To: Village of Orland Park Address: 14700 Ravinia Avenue Orland Park, IL 60462	Contact: Mr. Khurshid Hoda Phone: 708-403-6128 Email: khoda@orlandpark.org
Project Name: John Humphrey Complex Improvements Project Address: 14825 West Avenue Orland Park, IL 60462	Ref Number: CG19013 Date: 5/15/2019

V3 Construction Group proposes to perform the following work as a change order to the existing contract:

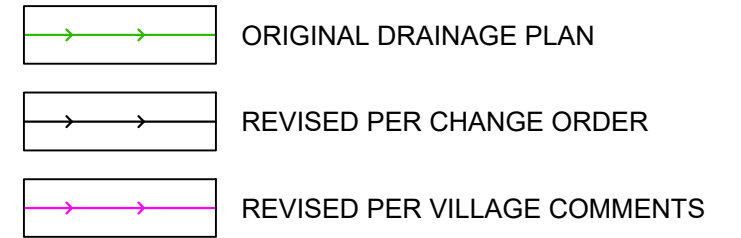
Original Bid	
12" Multi-Flow Drainage Installation	380 LF
6" Multi-Flow Drainage Installation	4,696 LF
Storm Sewer, 24" HDPE Mainline	673 LF
36" Dia. Catch Basin	3 EA
24" Dia. FES W/ Grate & Riprap	1 EA

Revised per Change Order	
12" Multi-Flow Drainage Installation	393 LF
6" Multi-Flow Drainage Installation	2,958 LF
Storm Sewer, 8" HDPE	865 LF
Storm Sewer, 12" HDPE	705 LF
Storm Sewer, 6" HDPE Perf.	4,146 LF
Cleanout	14 EA
4' Manhole	1 EA
24" Nyloplast Drain with 12" Dome Grate	9 EA

Revised per Village Comments	
Storm Sewer, 6" HDPE Perf.	582 LF

JOHN HUMPHREY PAVING IMPROVEMENTS EXHIBIT

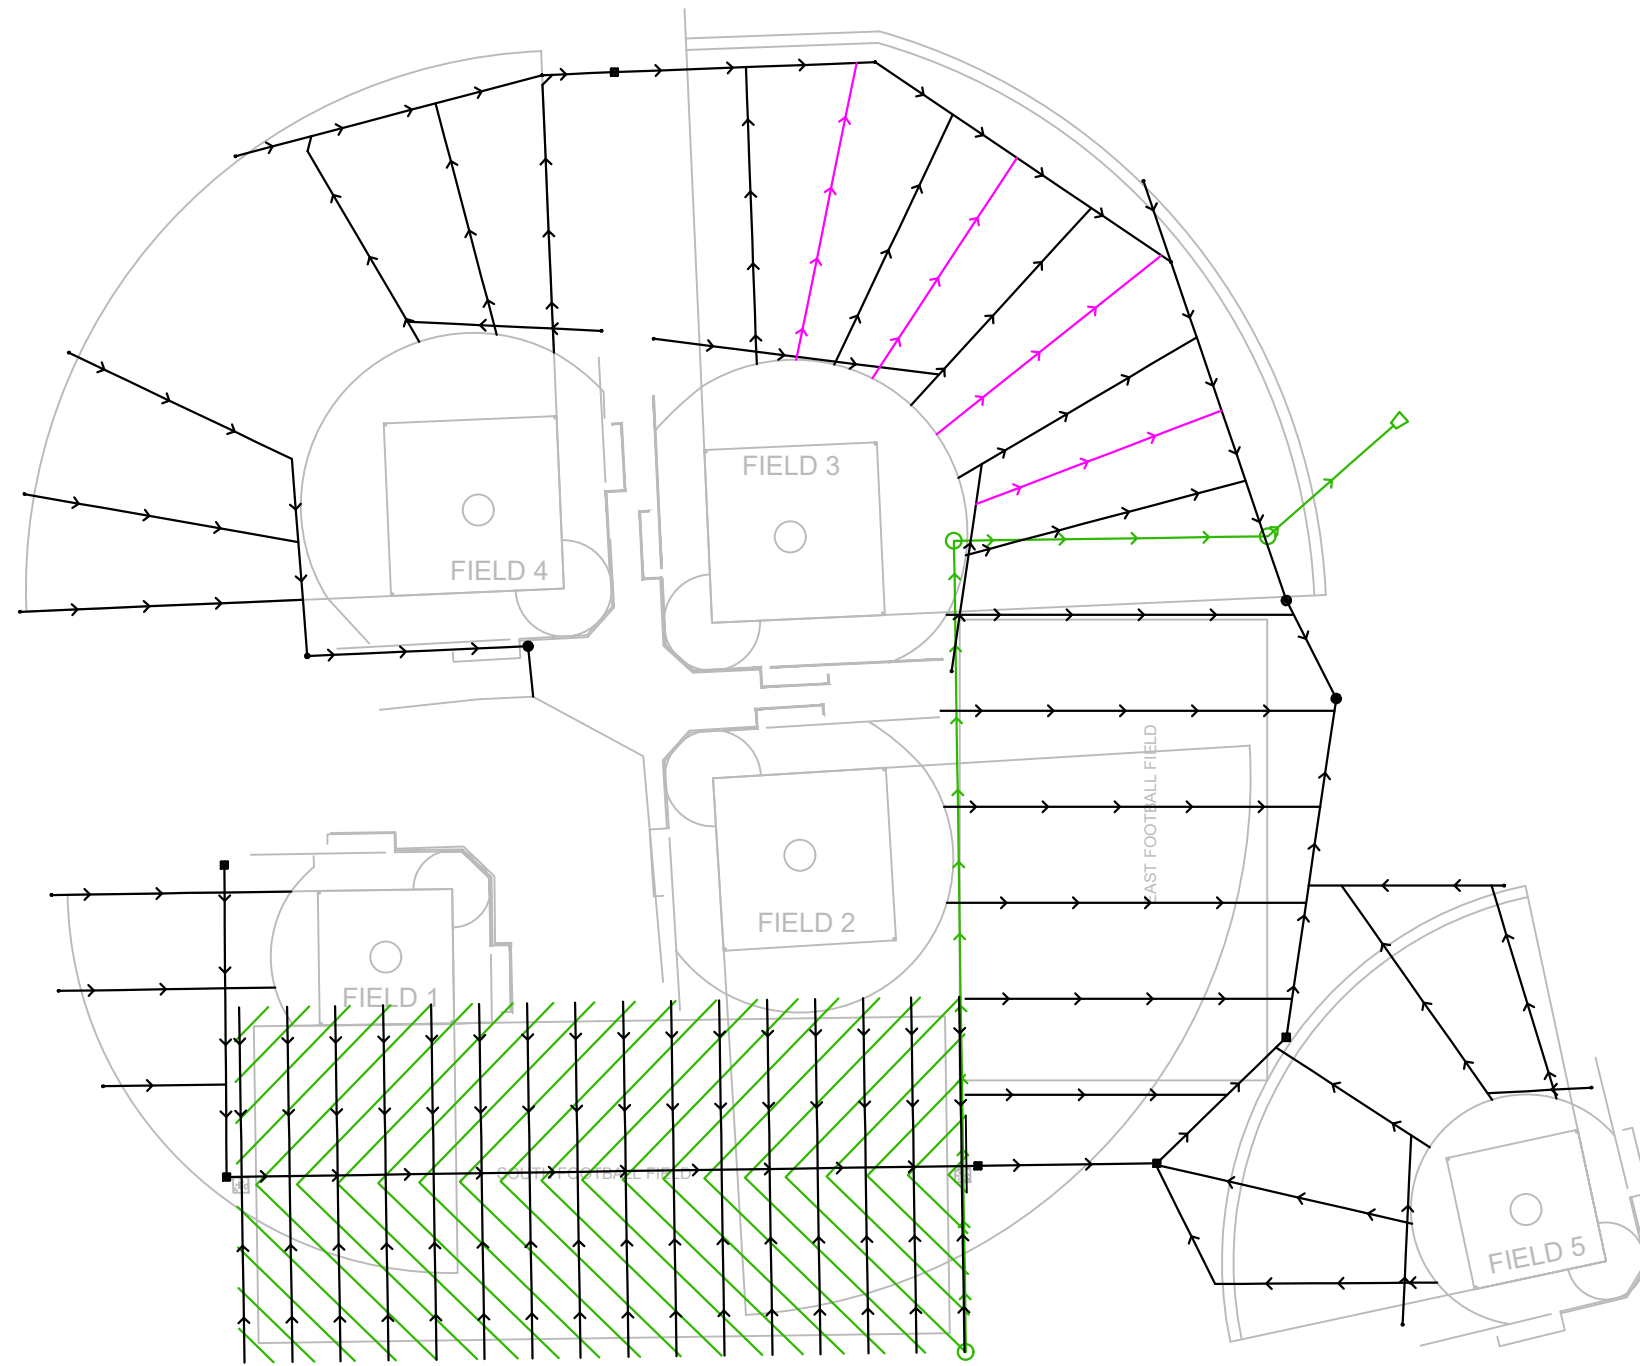
PATH RESTORATION - 3,260 SY
 PLAZA PAVEMENT R&R - 3,510 SY
